RE: **P.Z. 12-2013 The Wedge (McGrath Plaza)**: A request for a change of zoning from an existing "C8" Planned Commercial District to a new "PC" Planned Commercial District for 5 tracts of land totaling 5.26 acres located on the north side of Olive Street Road at its intersection with Chesterfield Airport Road. (17W620235, 17W620246, 17W610104, 17W610094, 17W610083)

Planning Commission Vote Report

Petition: **P.Z. 12-2013 The Wedge (McGrath Plaza)**

Revised Preliminary Plan

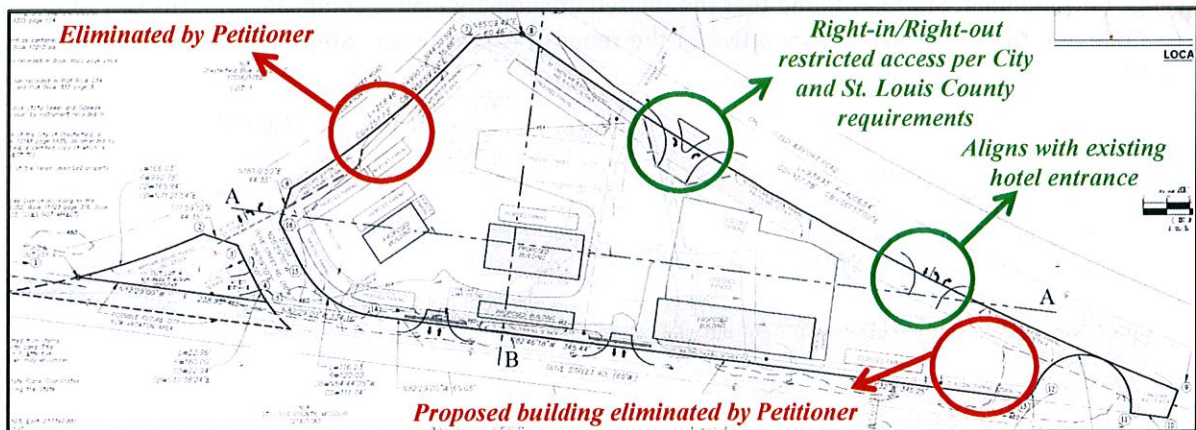
Following the Issues Meeting and subsequent meetings with Staff, the Petitioner provided an amended Preliminary Plan which made revisions to the site to address issues identified at the Public Hearing and by Staff. This revised Preliminary Plan maintains the landscape buffer along Chesterfield Airport Road and the relocated portion of Olive Street Road to the thirty (30) foot minimum requirement for commercial districts with frontage along arterial streets. In addition to this required buffer, the Petitioner revised the plan to include a fifteen (15) foot parking and building setback along Old Olive Street Road, which is no longer classified as an arterial street and is therefore not subject to any buffering requirement by the Municipal Code. Despite the lack of required buffering along this frontage, the addition of a building and parking setback alleviates Staff's concern of parking fields commencing at the property line.

Additionally, the Petitioner eliminated the small building in the far eastern corner of the site. In eliminating this building, the Petitioner has significantly reduced the previously proposed intensity of the site and provided a plan that better suits this highly irregularly shaped property. Further, it is Staff's opinion that the elimination of this building will facilitate improved internal circulation and provide more area for the Petitioner to meet City Code requirements, including parking, open space, and landscaping requirements, outright without requesting several modifications from Code during the Site Plan review phase.

Finally, as requested by Staff and the Planning Commission, the Petitioner eliminated the access point off of relocated Olive Street Road. The remaining access points have been evaluated by Staff and, given the unique shape of this property, the accesses as shown have found to be appropriate for a development of this size and intensity. Staff maintains that the elimination of the relocated Olive Street Road access will allow for safe access into the site as well as improved internal site circulation. The Attachment "A" prepared by Staff reflects what is shown on the Preliminary Plan and satisfies Staff's concerns.

- Concerns regarding the number and location of access points off of Olive Street and Chesterfield Airport Roads.

- The excerpt from the revised Preliminary Plan shows the substantial revisions that the Petitioner has made on the Preliminary Plan. The property frontage on the relocated Olive Street Road equates to approximately 360 feet. This frontage is located between the remaining portion of Olive Street Road and Chesterfield Airport Road and did not provide adequate spacing for the proposed access onto relocated Olive Street Road. **As such, per Staff recommendation, the Petitioner eliminated this access, as shown below.**

Note that a deceleration lane and geometric channelization has been added to the configuration of the westernmost access point along Chesterfield Airport Road. This will allow for safe right-in/right-out only turning movements and will mitigate any negative effects on traffic flow along Chesterfield Airport Road. The two access points along old Olive Street Road meet drive spacing requirements for a local street and will improve internal site circulation.

PRELIMINARY DEVELOPMENT PLAN
 18423 OLIVE ST. RD.

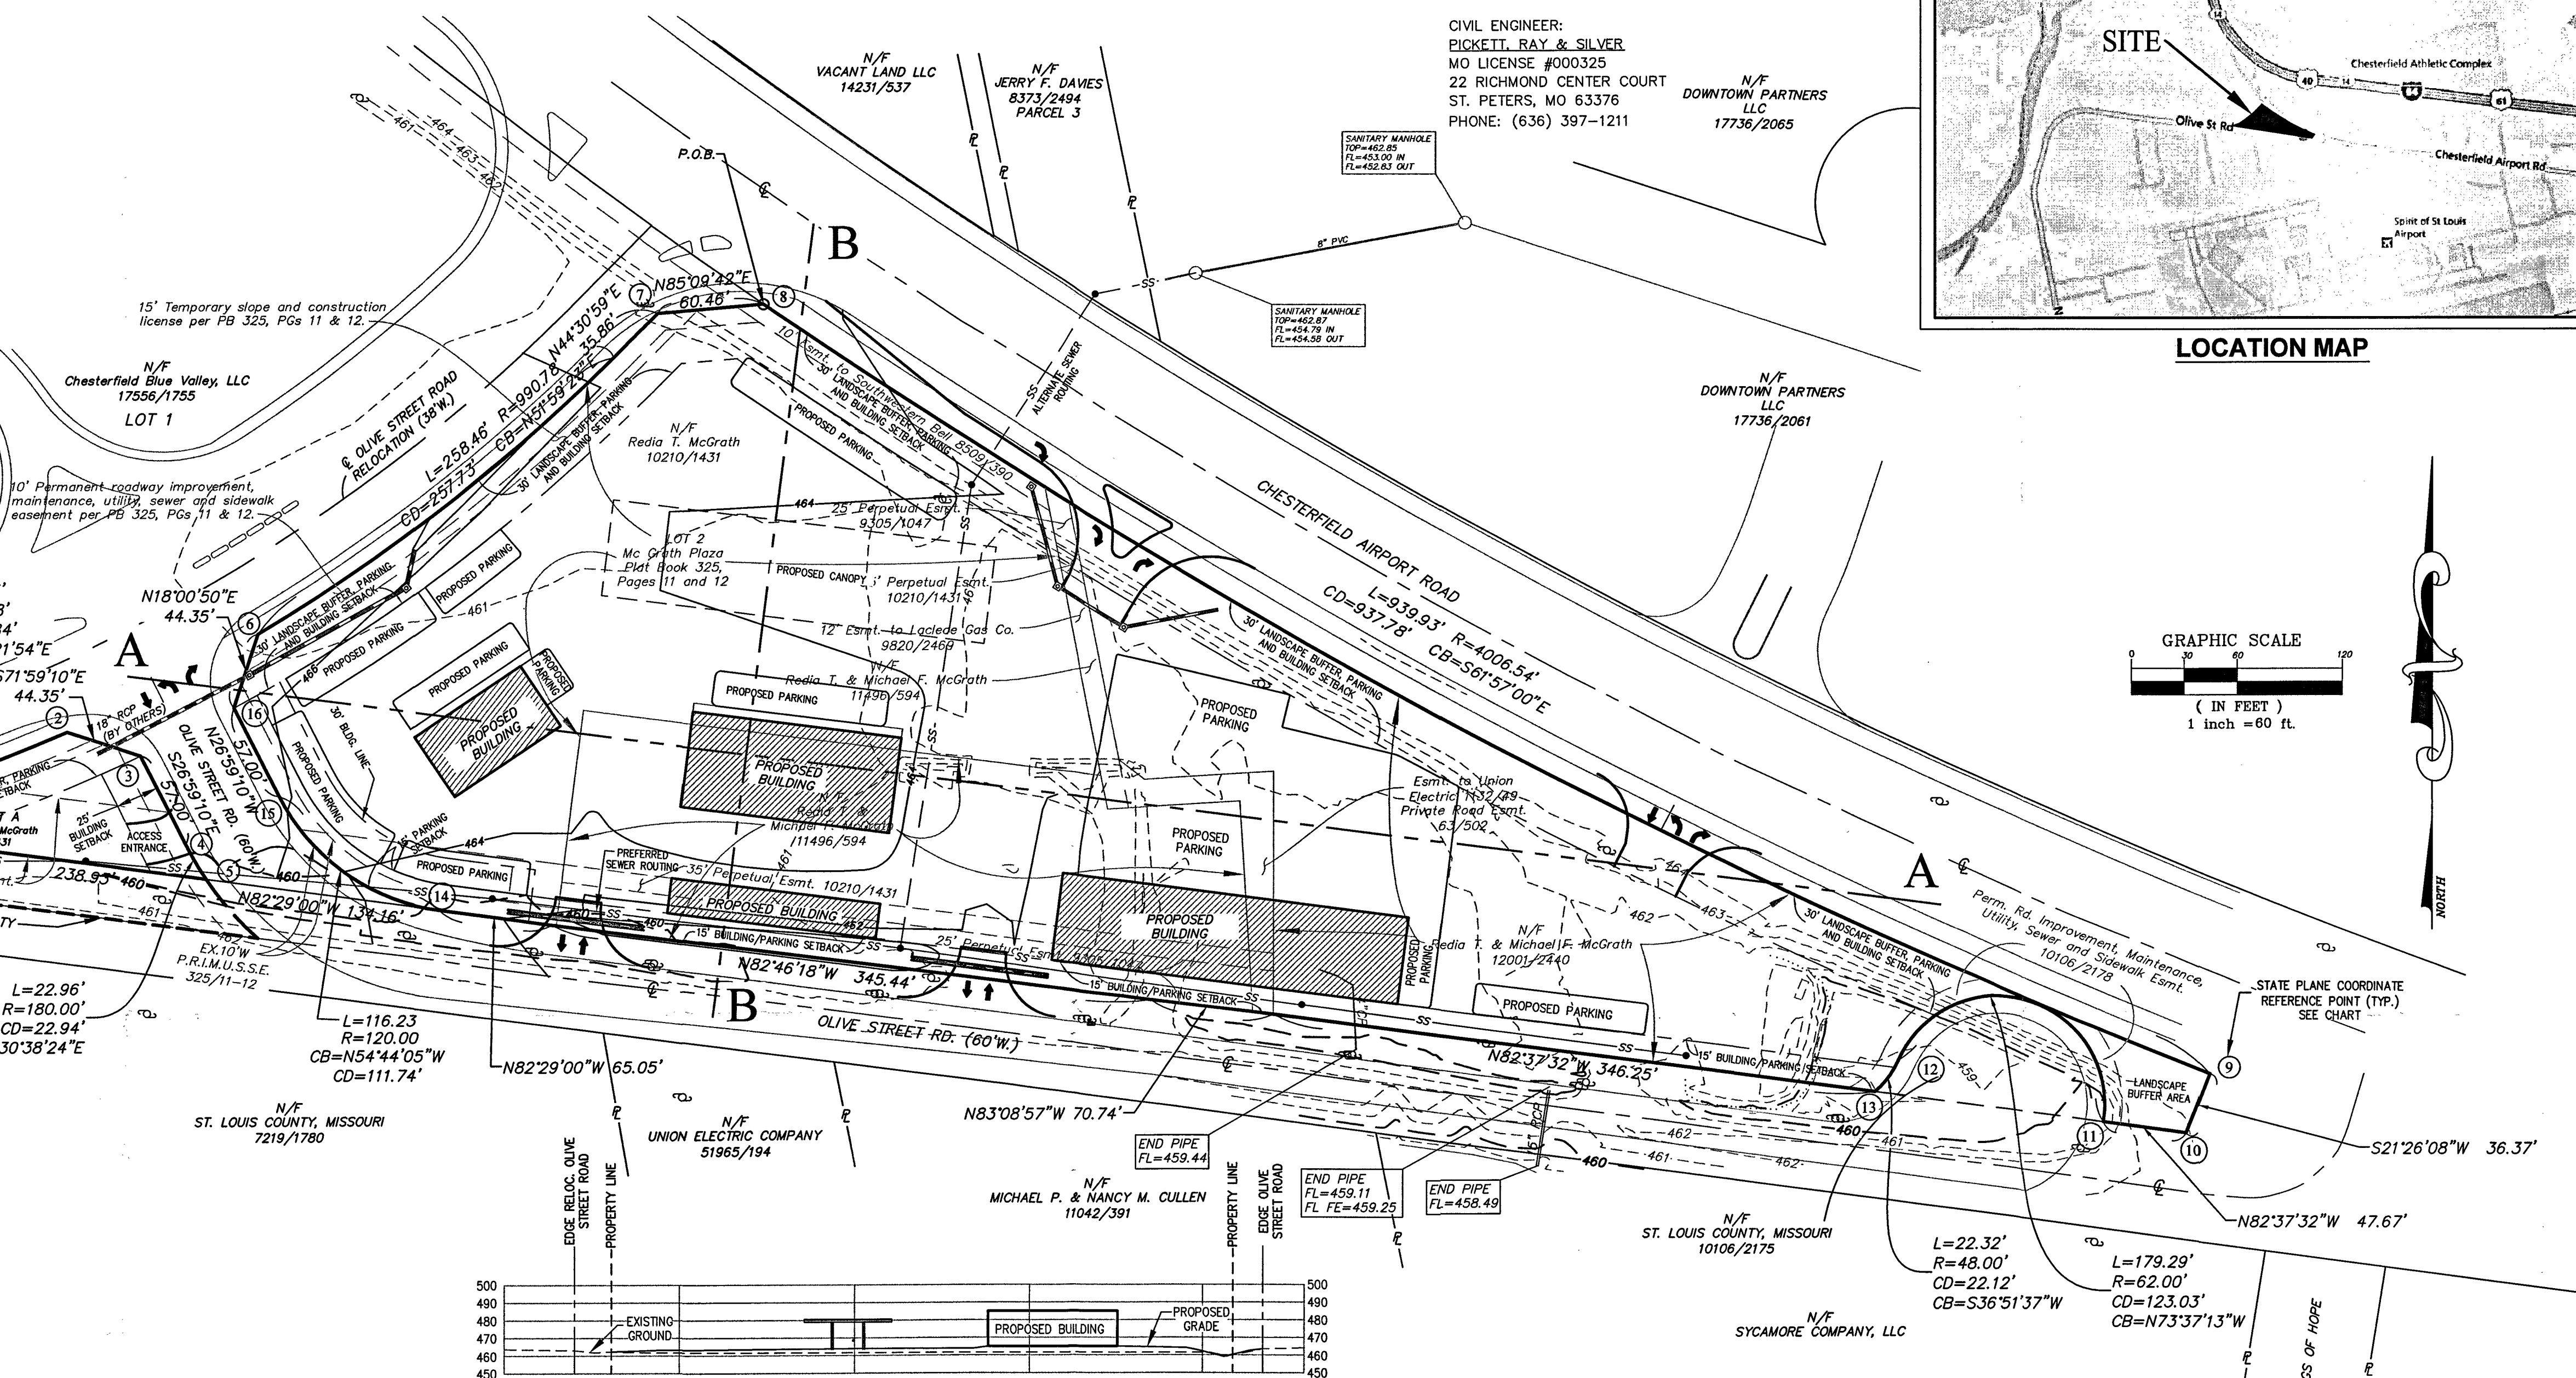
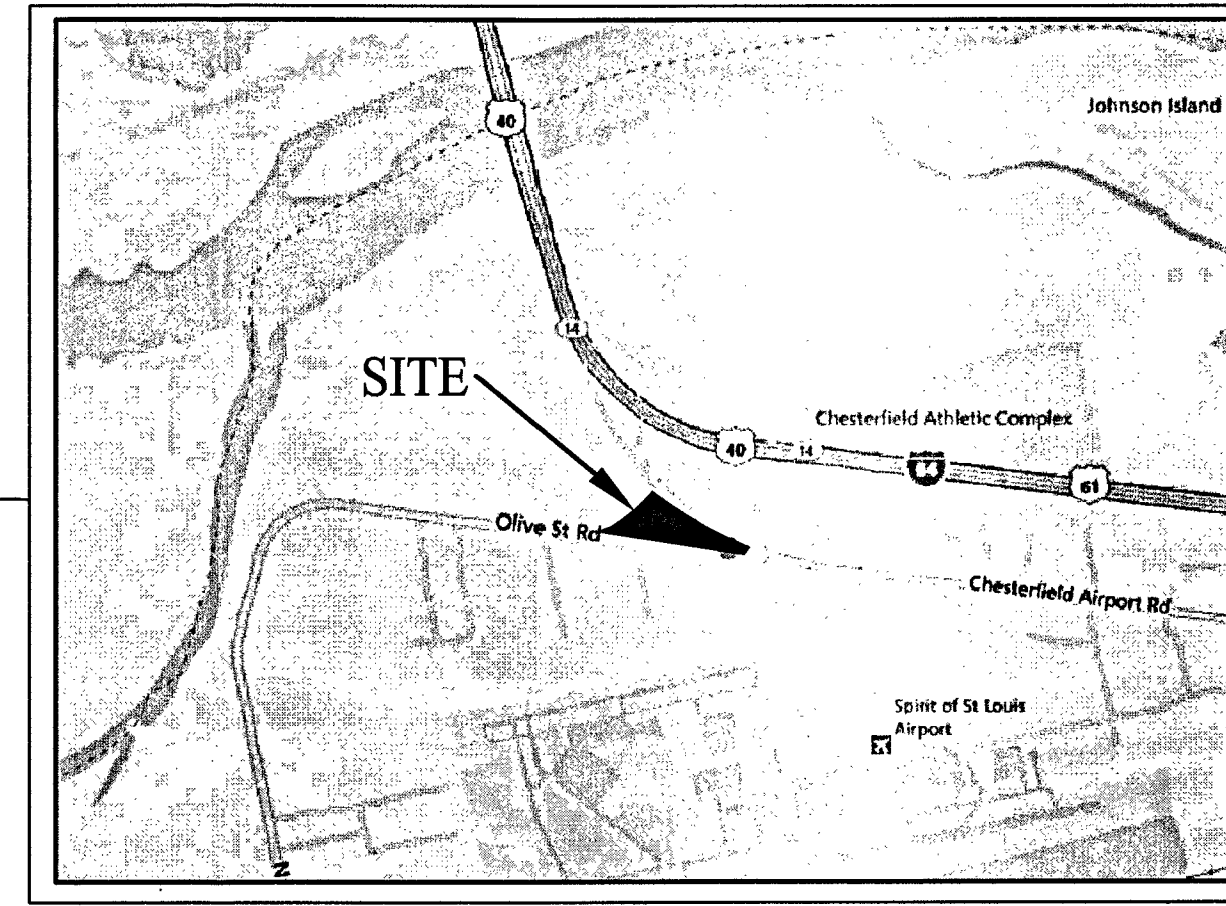
- **Concerns with requested setbacks and lack of landscape buffers as required by the tree preservation and landscape requirements of the Municipal Code.**

As discussed in the Analysis section of this report, the Petitioner revised the Preliminary Plan to meet the thirty (30) foot minimum landscape buffer requirement for commercial districts with frontage along arterial streets and to provide a fifteen (15) foot parking and building setback along Old Olive Street Road.

- **Concerns with the ability of the development as shown on the Preliminary Plan to achieve the minimum thirty-five percent (35%) Open Space requirement through distribution of Open Space throughout the site.**

This issue is advisory at this point; however, Staff believes that the elimination of one of the buildings will enable the development to more easily meet the minimum open space requirement and will facilitate the distribution of said open space throughout the site.

Staff has reviewed the request for a zoning map amendment submitted by Pickett, Ray & Silver, Inc. for The Wedge development. Staff has found that the revised Preliminary Plan is compliant with the City of Chesterfield City Code and therefore Staff is supportive of the request as presented. Staff requests action on P.Z. 12-2013 The Wedge (McGrath Plaza).
